RE: Willis Avenue Lakeshore Barrier Wall IRM (Site No.: 734026)
Restoration/Mitigation Design
Village of Solvay, Onondaga County, NY
Order on Consent: Index # D7-0004-01-09

RESPONSES TO NYSDEC COMMENTS ON THE RESTORATION/MITIGATION DESIGN FOR THE WILLIS AVE./SEMET TAR BEDS SITES

**Figure C-1
Willis Restoration/Mitigation Schedule**

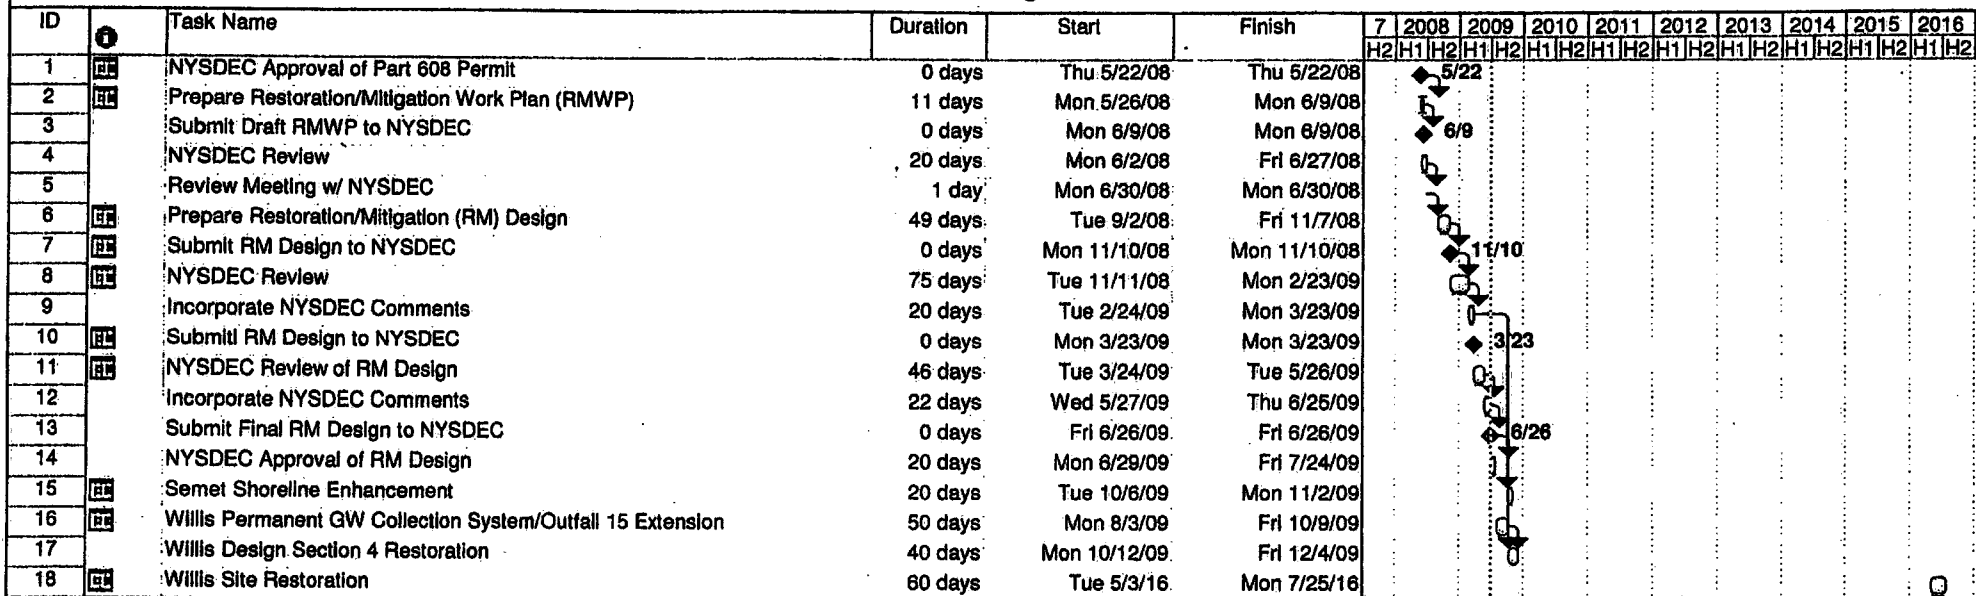
- The annual goal for percent cover is 85% following the second full growing season for the conservation and wetland seed mix species. If total percent cover falls below 85%, select areas will be re-seeded.
 - In terms of the tree (including willow) and shrub species, the text will be modified to include maintaining approximately 85% of the species for a five year period. If a single species makes up a substantial portion of the failed vegetation, a new species will be selected from Table B-3.
 - As indicated in Section 6 – Maintenance, an initial mowing of the cover crop is anticipated. The O&M contractor for the project site will be notified following planting to avoid mowing restored areas.
6. Attachment C – Schedule – The schedule should be revised as needed for the revised document.

Response: The document has been revised accordingly.
